Office Action Summary	Application No.	Applicant(s)	
	10/814,658	CATRY ET AL.	
	Examiner	Art Unit	
	Gary L. Welch	3765

DETAILED ACTION

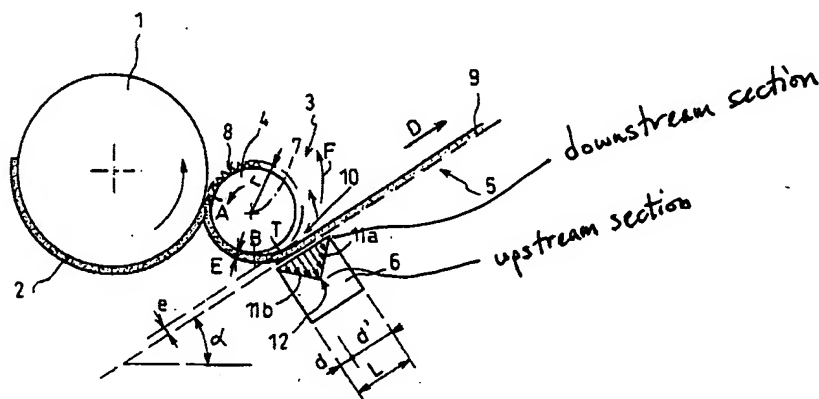
With regard to claim 28, only one second stage is provided wherein the vacuum speed decreases gradually from upstream to a downstream section (see figure above).

With regard to claim 29, the secondary section is a vacuum zone and has a plurality of successive stages (see figure above).
